Green Life Knit Composite Ltd. (Extension)

Tongabari, Ashulia, Savar, Dhaka-1341
(23.903056N,90.320529E)
10 September 2023

Observations

Lack of bracing and beam size along N-S direction

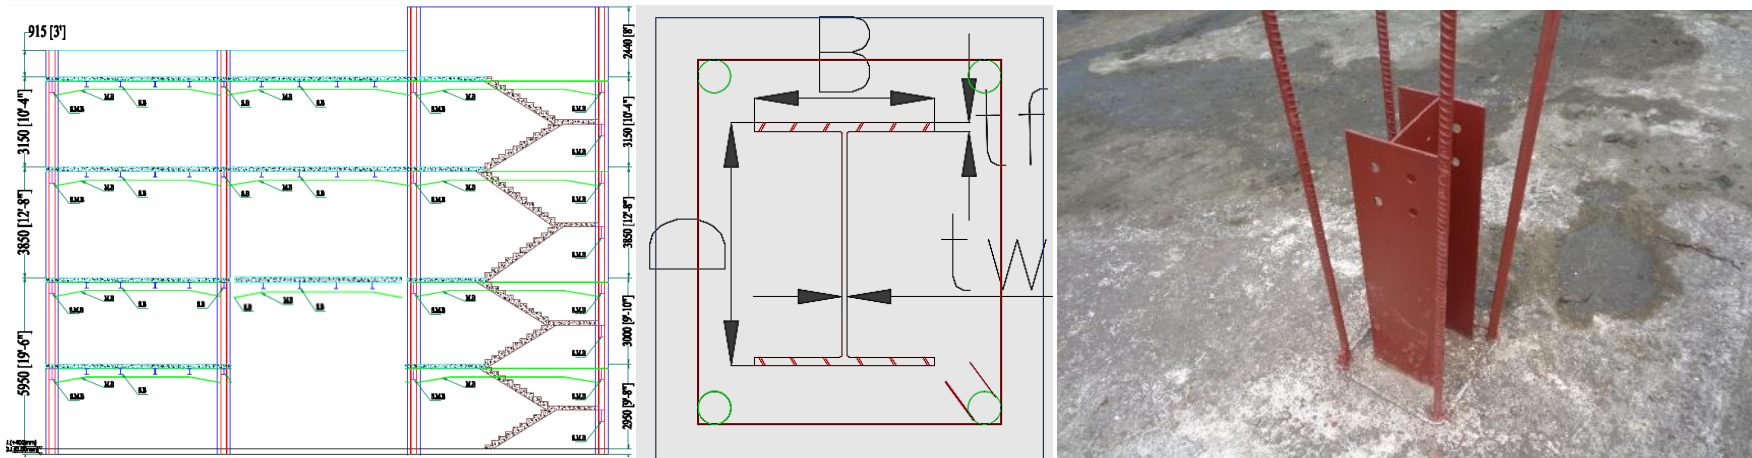
**Inadequate lateral stability system
along N-S direction**

There is no bracing along N-S direction and the depth of secondary framing beam size is very low which indicates lack of lateral stability of the building along this direction. The building engineer is required to check the stability system and suggest necessary alternatives accordingly.

Missing information & connection details in the provided drawing

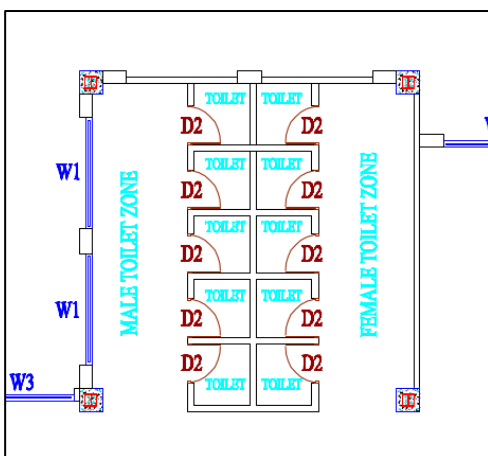
Column size, rebar diameter, steel to RC connection, Steel column to beam connection details are missing in the drawing

350 mm floor build up at toilet zone not shown in the drawing

Composite column was found on-site. Steel column to beam connection details as well as rebar detailing is not provided in drawing.

Building engineer is required to survey the structure, verify the connections between RC and steel member and prepare accurate the as-built drawings.

Missing information and discrepancy in the provided drawing

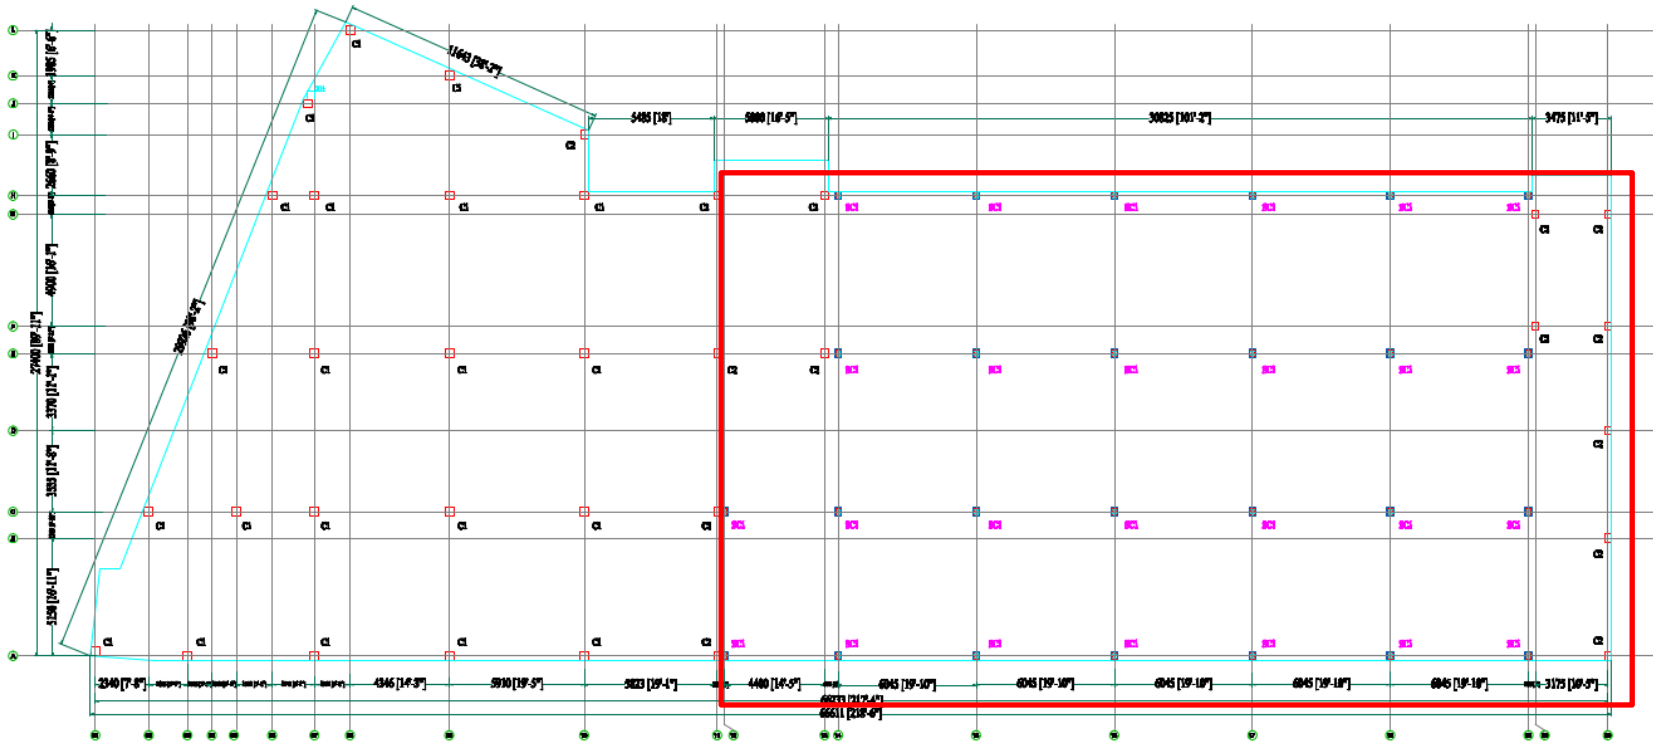
10 rebars shown in the drawing

8 rebars (3 on each side) found on-site

8 rebars (3 on each side) found on-site instead of 10 rebars. Building engineer is required to check the column rebar and update the as-built structural drawing accordingly.
